September 16, 2021

**Re: Initial Submission Review – Green Valley Ranch East Site Plan No. 5 - Site Plan Amendment with Adjustment and Replat**  
Application Number: **DA-1662-22**  
Case Number(s): 2019-4022-01; 2021-3043-00

On behalf of Oakwood Homes and Terracina Design, we have reviewed the comments dated August 26, 2021. The following is a response to comments.

DATE OF PREPARATION:	06-03-2021
SCALE:	N/A
SHEET 1 OF 3

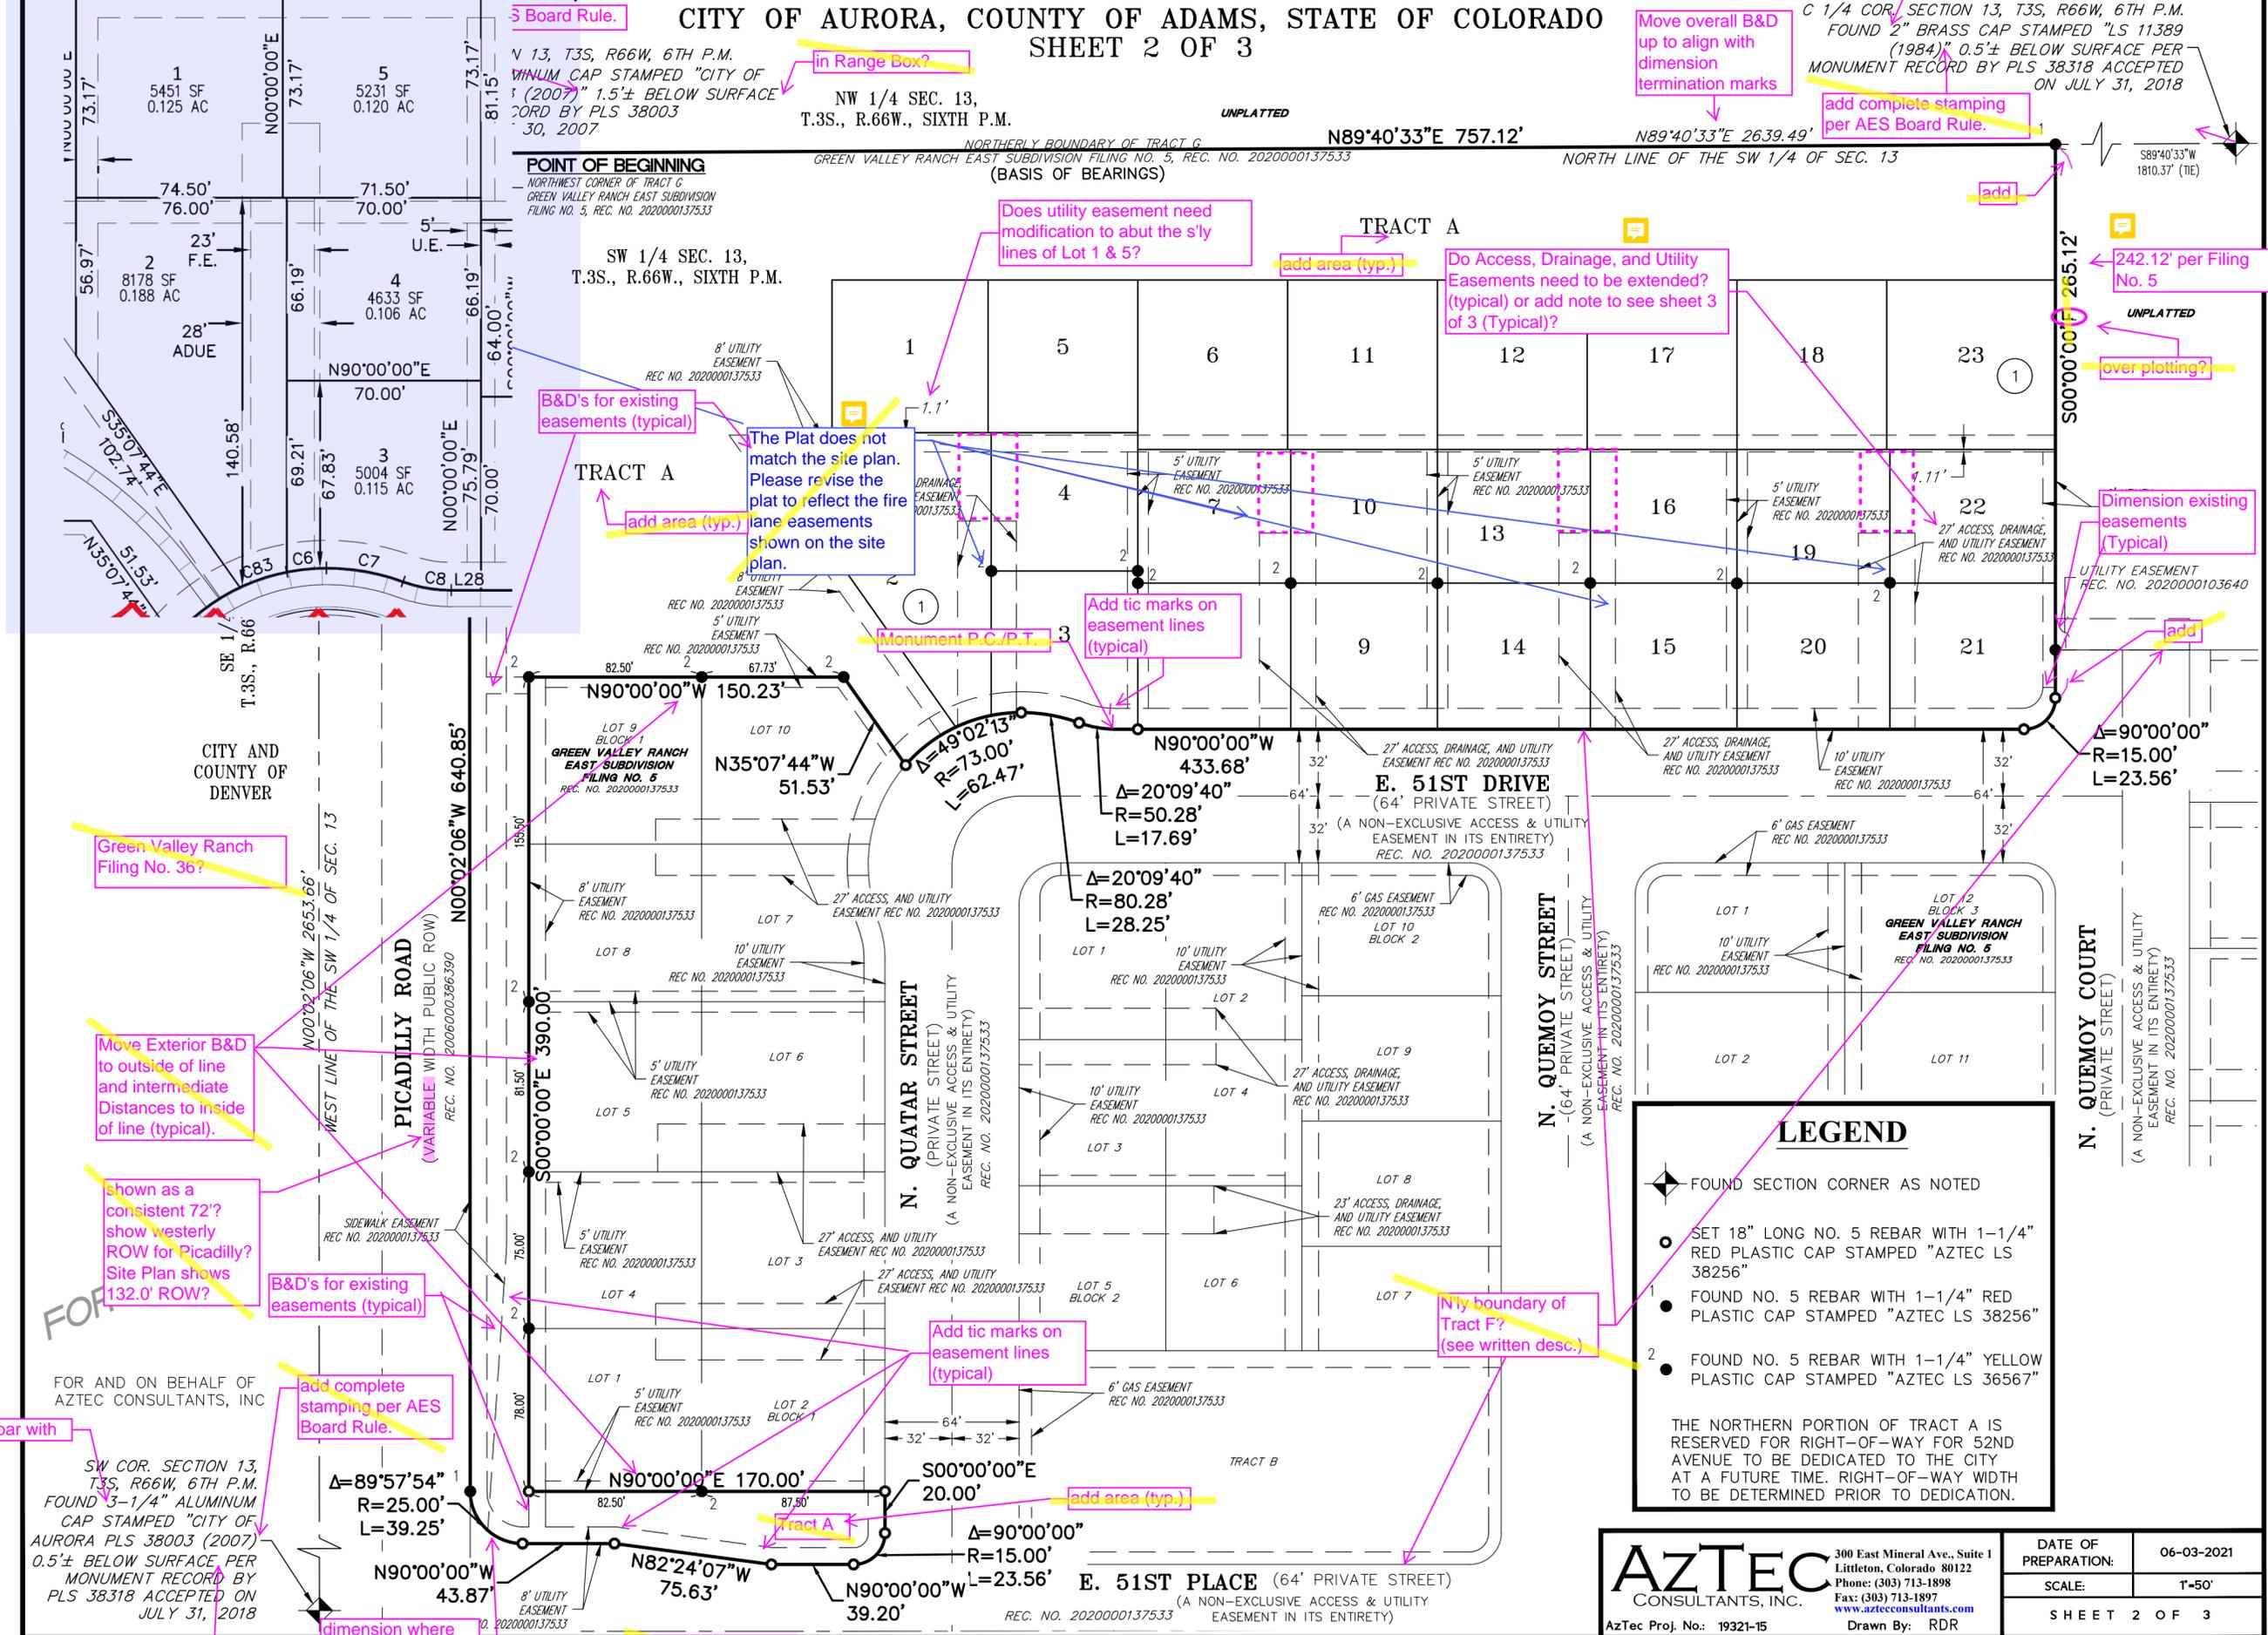
Graphics also show the north line of Tract G?

ENGINEER \_\_\_\_\_ DATE \_\_\_\_\_ CITY \_\_\_\_\_  
PLANNING DIRECTOR \_\_\_\_\_ DATE \_\_\_\_\_  
Move to precede Engineer

DANIEL E. DAVIS, LICENSED PROFESSIONAL LAND SURVEYOR  
COLORADO P.L.S. NO. 38256  
FOR AND ON BEHALF OF AZTEC CONSULTANTS, INC.  
Add date last observed in the field.

### LOT AND UTILITY EASEMENTS DETAIL

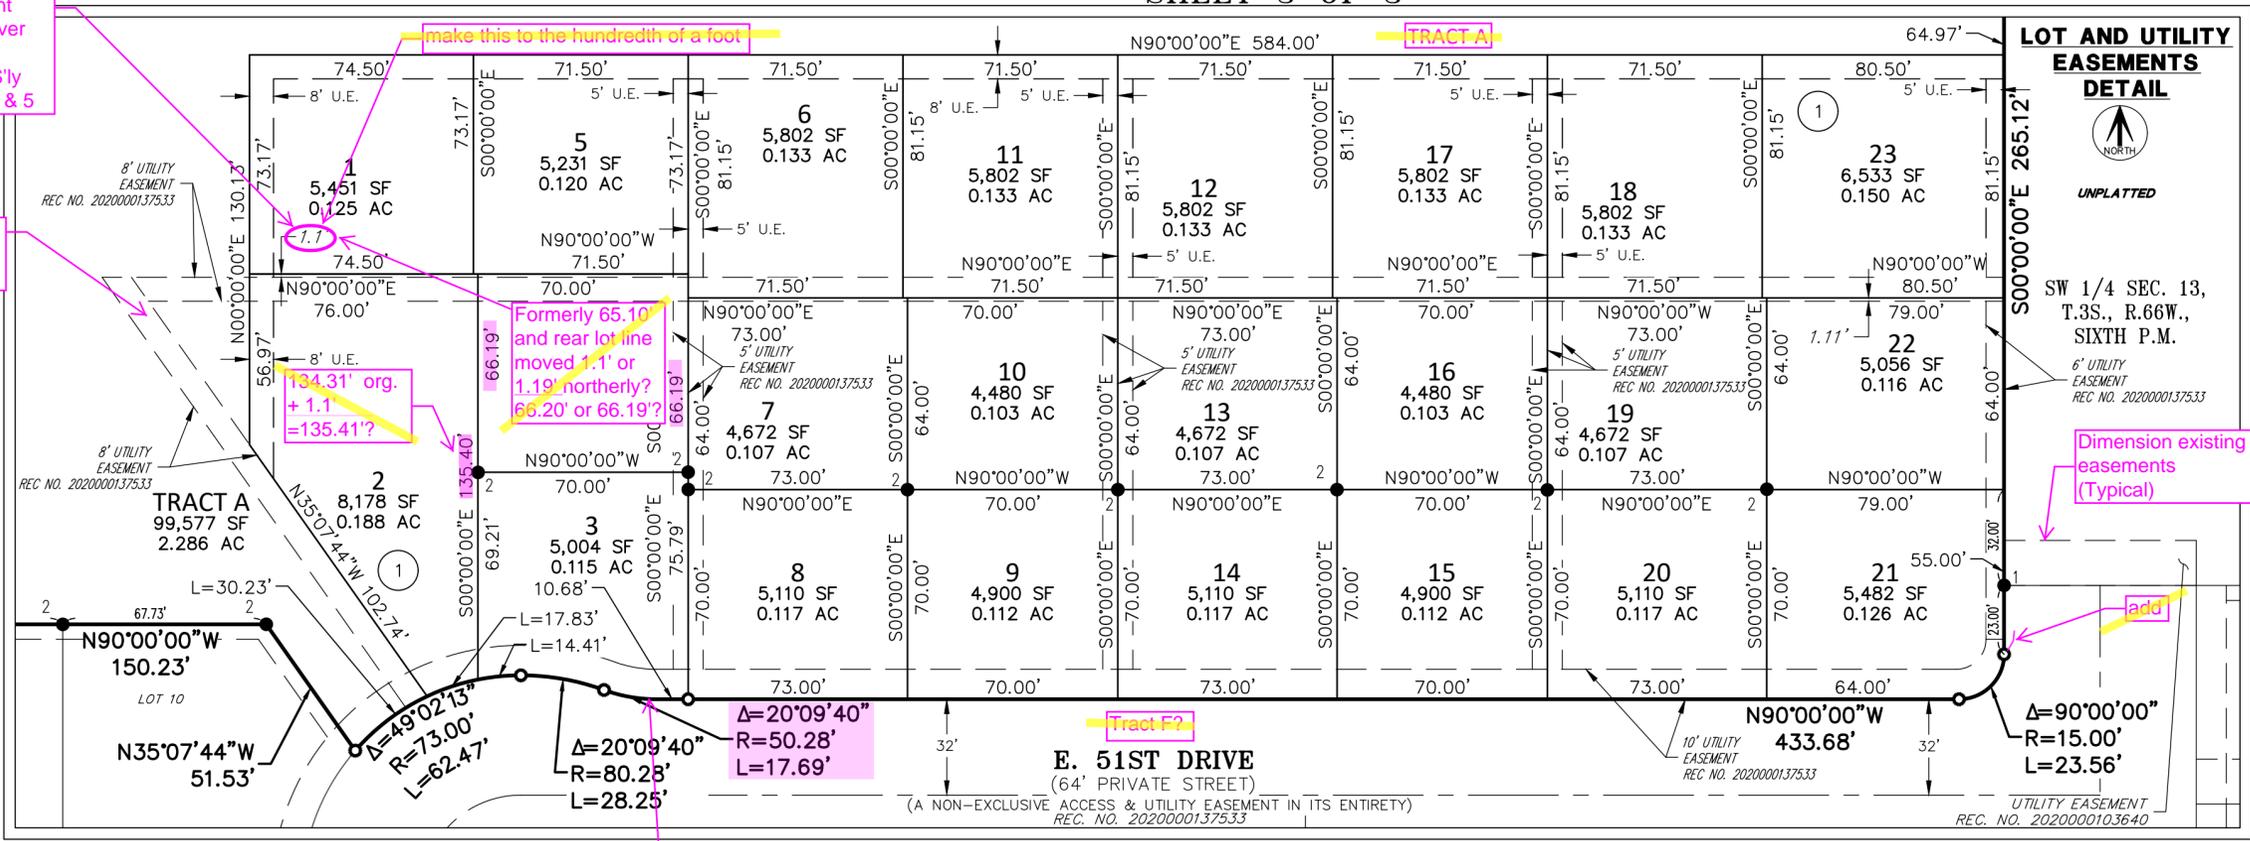
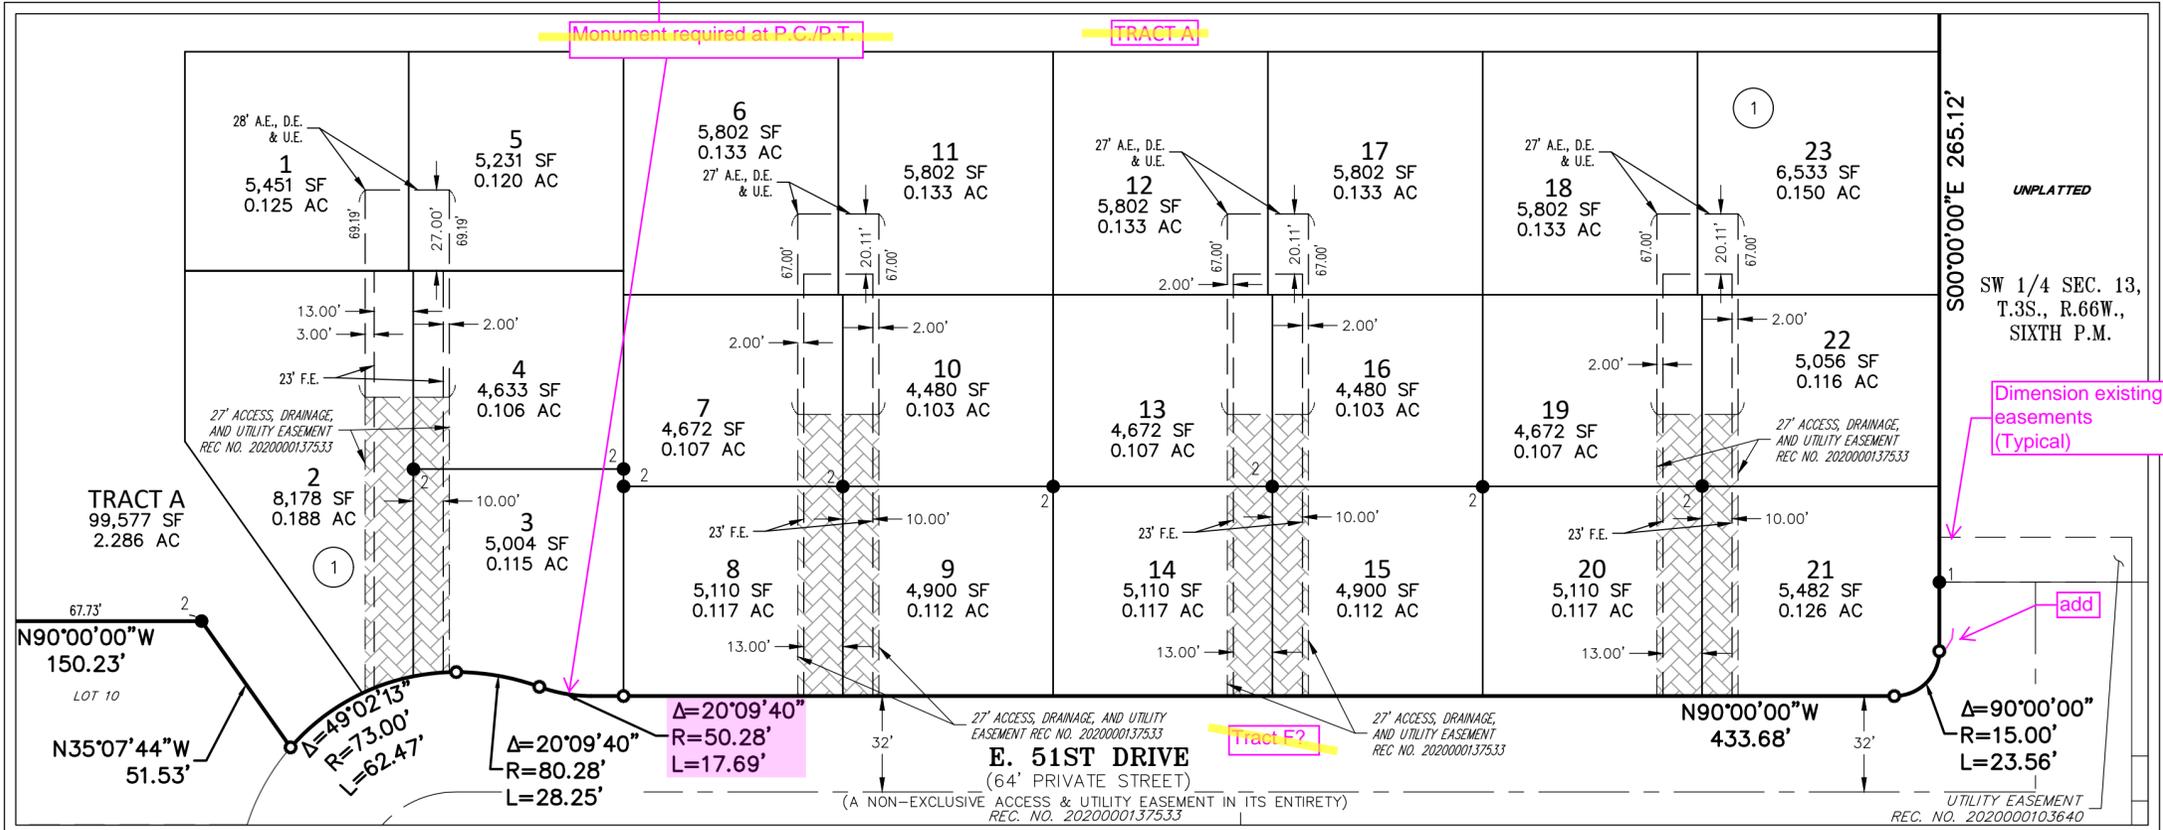
Formerly 65.10' and rear lot line moved 1.1' or 1.19' northerly? 66.20' or 66.19'?

Dimension existing easements (Typical)

Monument required at P.C./P.T.

Dimension existing easements (Typical)

**GREEN VALLEY RANCH EAST  
PRELIMINARY PLAT #5  
TEMPORARY STREET INTERSECTION**

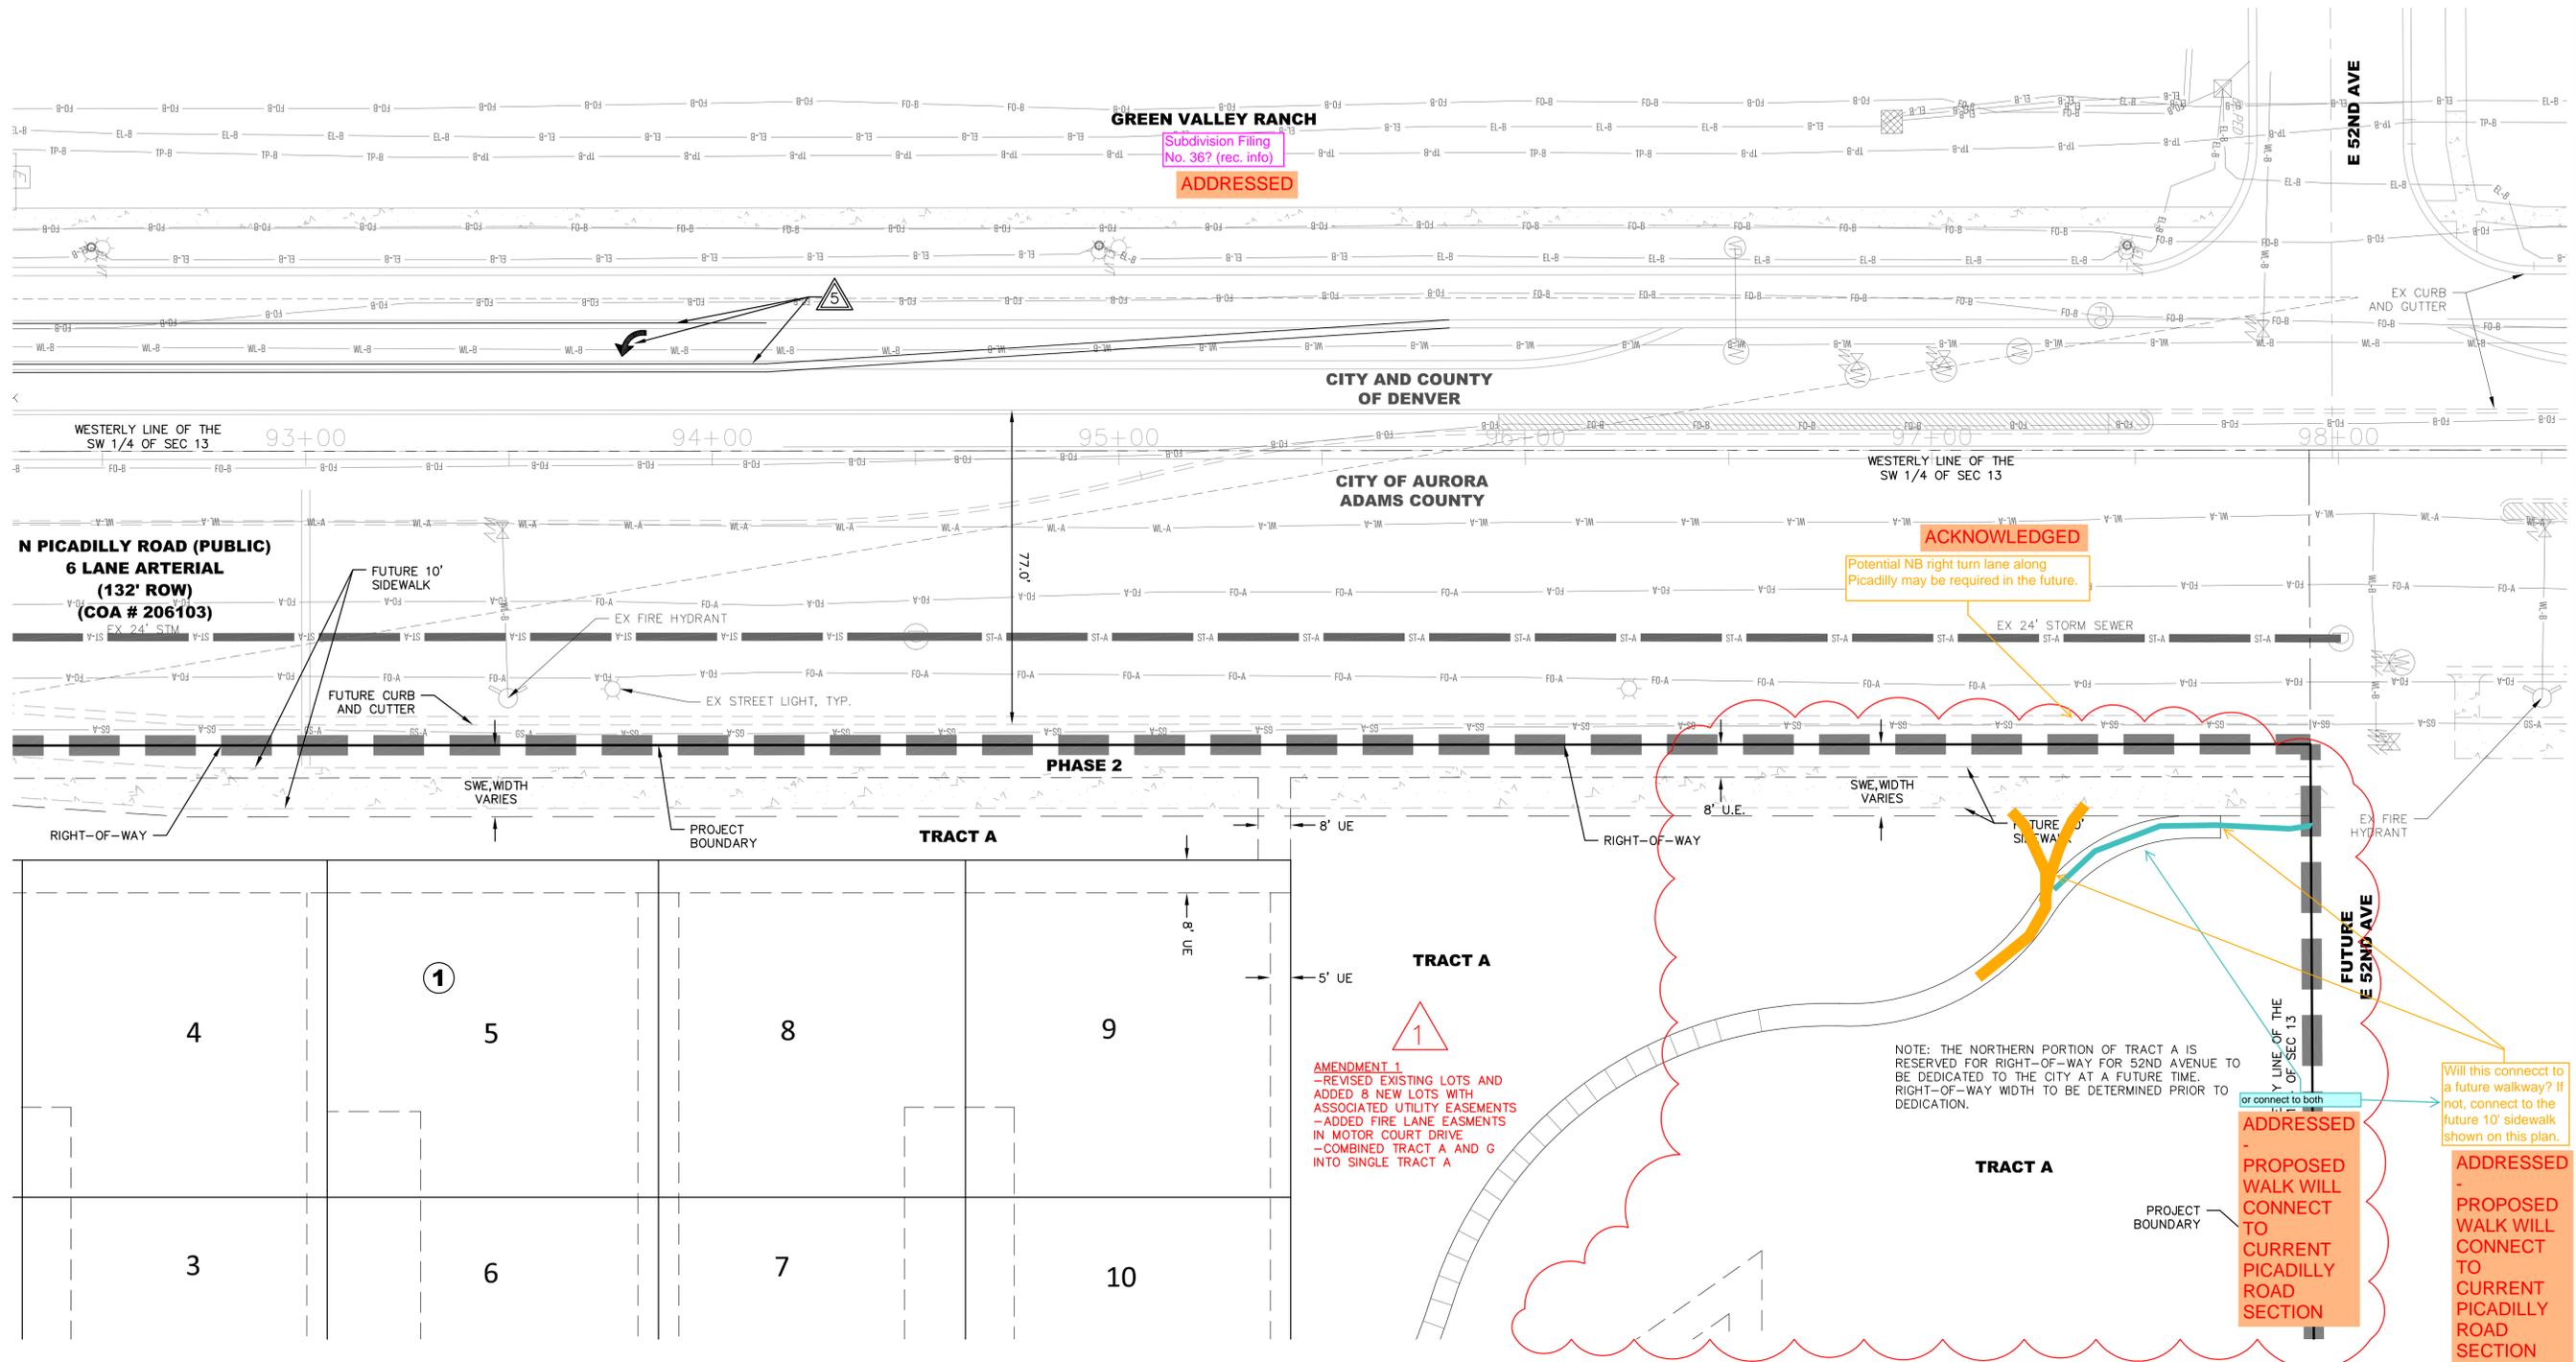
**ACKNOWLEDGED**  
Potential NB right turn lane along Picadilly may be required in the future.

**ADDRESSED**  
- Will this connect to a future walkway? If not, connect to the future 10' sidewalk shown on this plan.  
- PROPOSED WALK WILL CONNECT TO CURRENT PICADILLY ROAD SECTION
